BELL BEND NUCLEAR POWER PLANT
RESPONSE TO RAI No. 37 AND
SCHEDULE INFORMATION
BNP-2009-244 Docket No. 52-039

References: 1) M. Canova (NRC) to R. Sgarro (PPL Bell Bend, LLC), Bell Bend COLA – Request for Information No. 37 (RAI No. 37) – SEB1 -2659, 2660, 2661, e-mail dated July 27, 2009

Response to NRC Request for Additional Information No. 37
Bell Bend Nuclear Power Plant

FIGURE 1-6

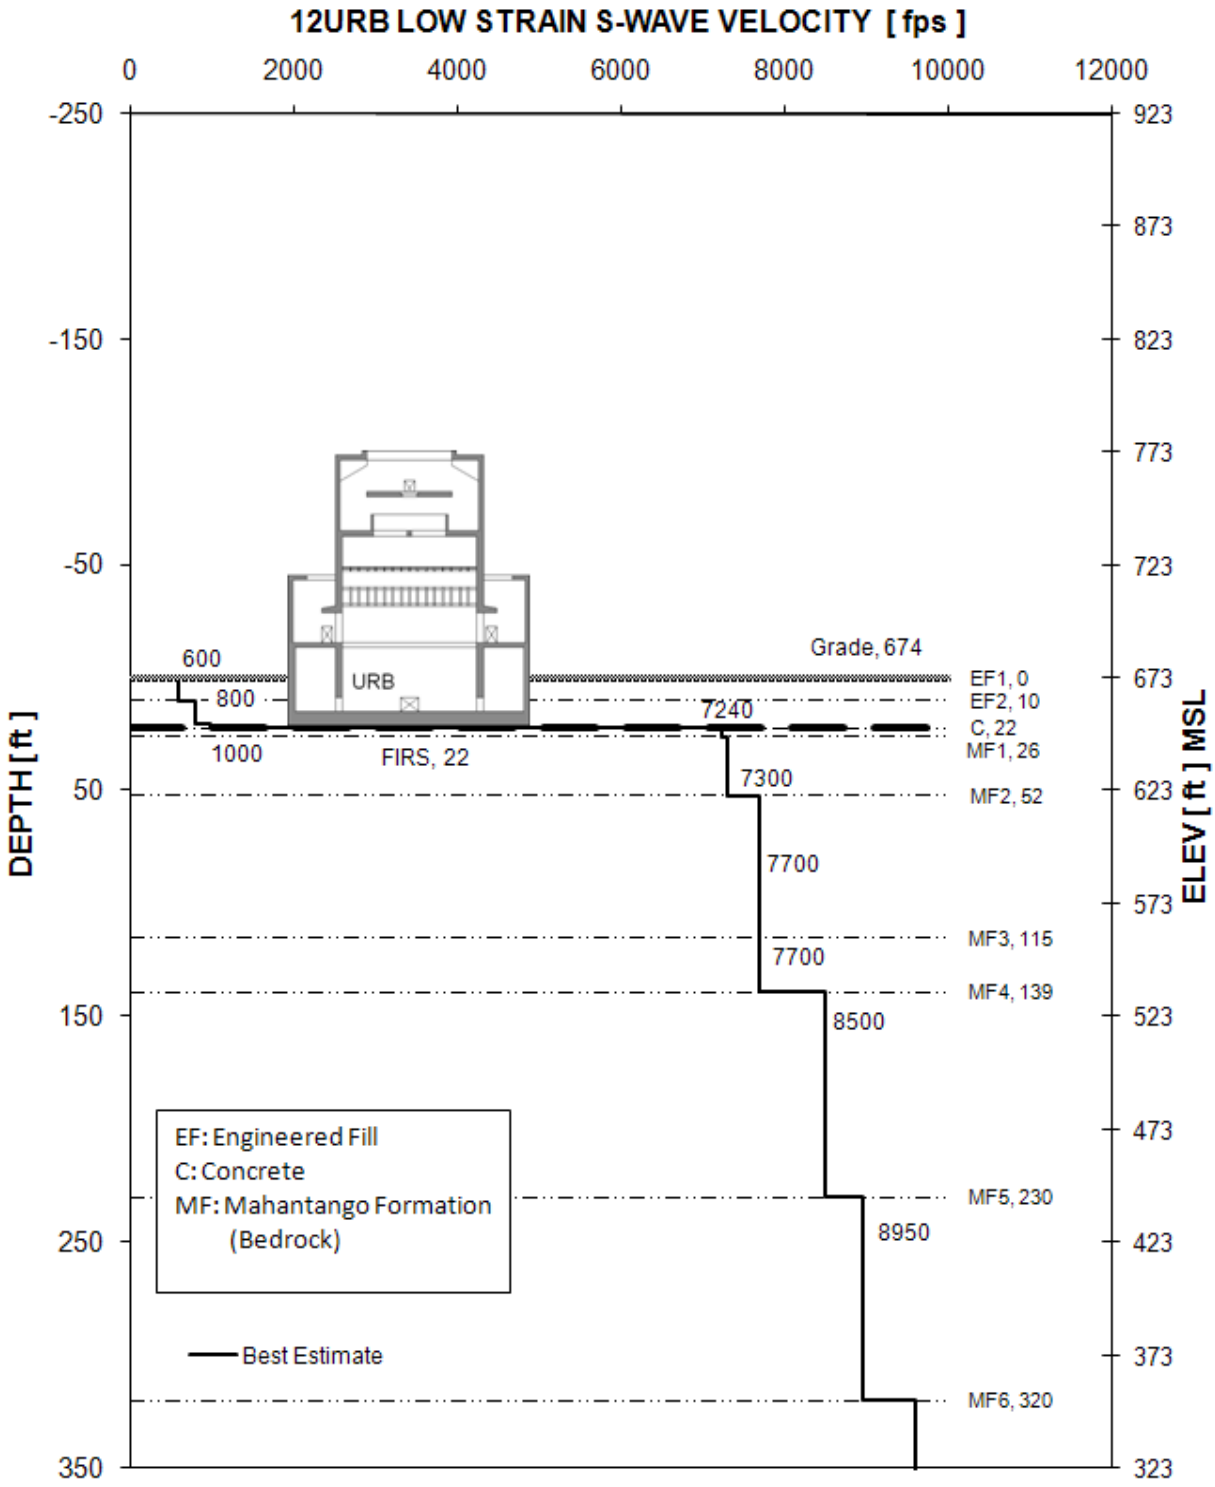
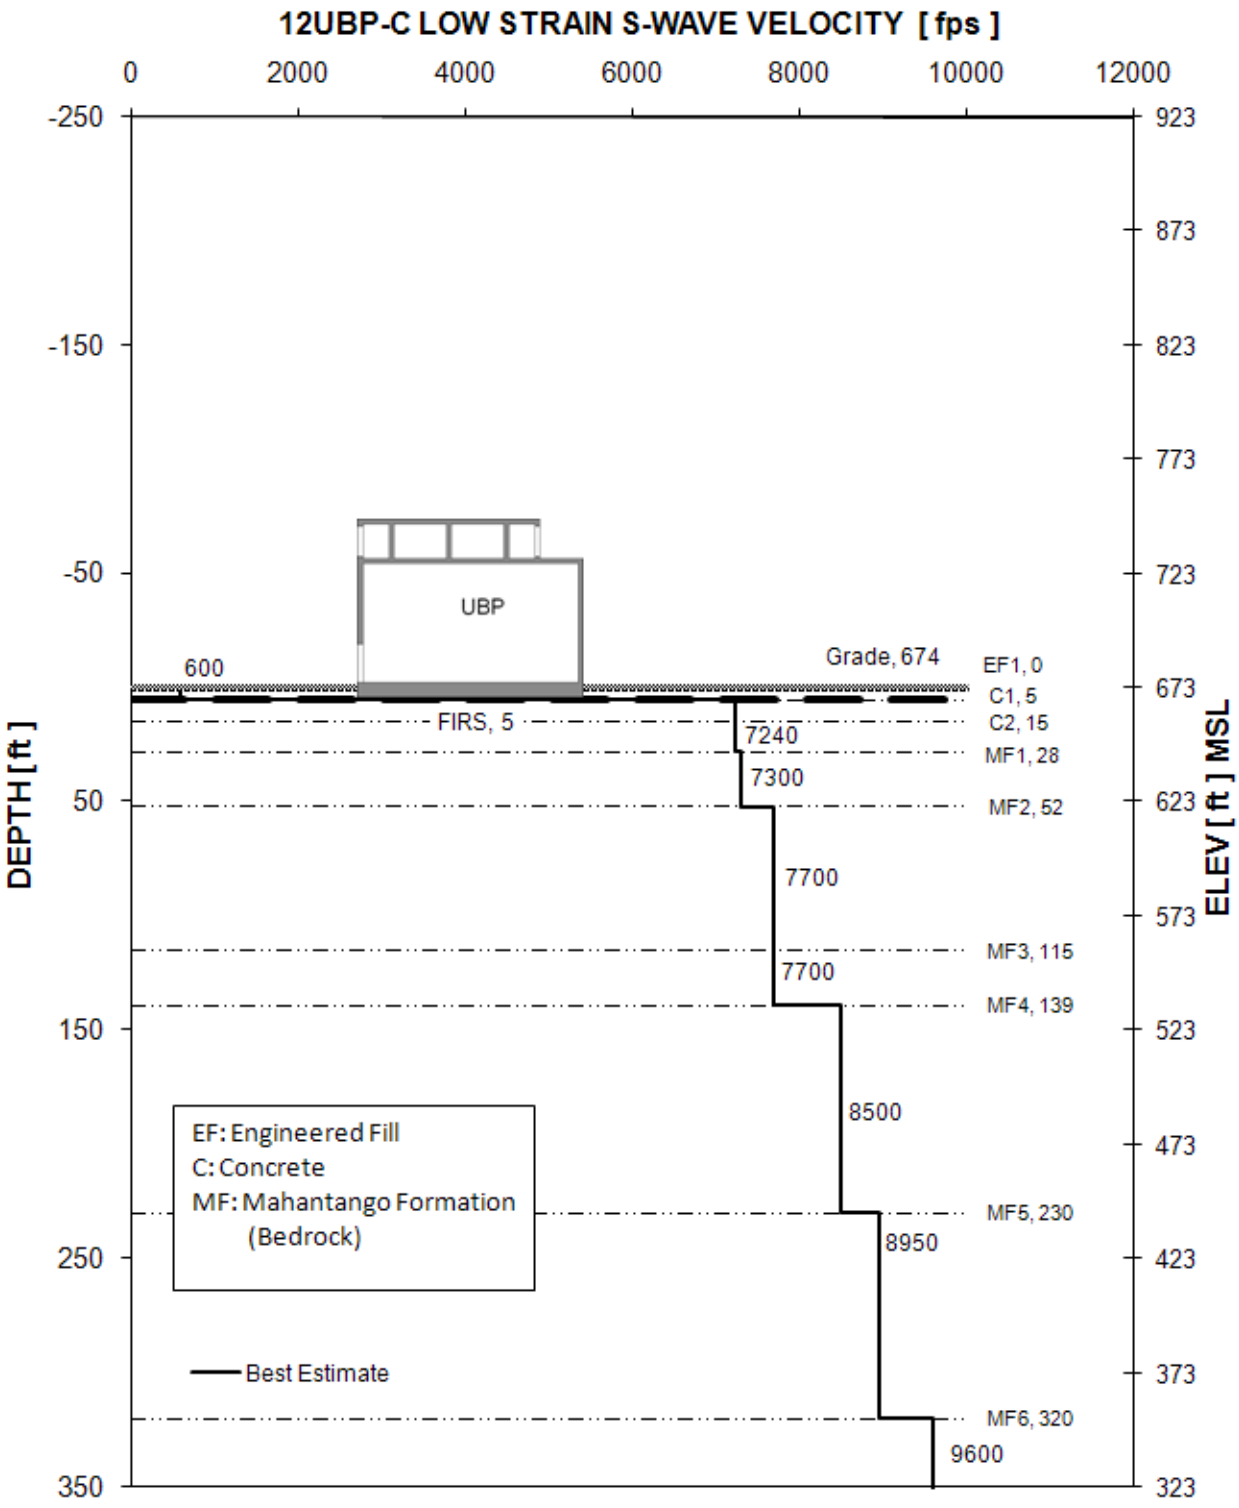
1) Describe in detail the process used to develop the FIRS and indicate if the FIRS were developed in a probabilistic manner. State if the site profiles used in the calculations were based on the geologic outcrop at the foundation elevation of each structure.

The FIRS for each building in the power block area was developed independently to accommodate a specific soil column. A figure is provided for each of the facilities as follows:

- Figure 1-1 – General plan view and building nomenclature
- Figure 1-2 – Soil profile underneath the Nuclear Island (NI)
- Figure 1-3 – Soil profile underneath 3URB (ESWB)
- Figure 1-4 – Soil profile underneath 4URB (ESWB)
- Figure 1-5 – Soil profile underneath 3UBP and 4UBP (EPBG)
- Figure 1-6 – Soil profile underneath 1URB and 2URB (ESWB)
- Figure 1-7 – Soil profile underneath 1UBP and 2UBP
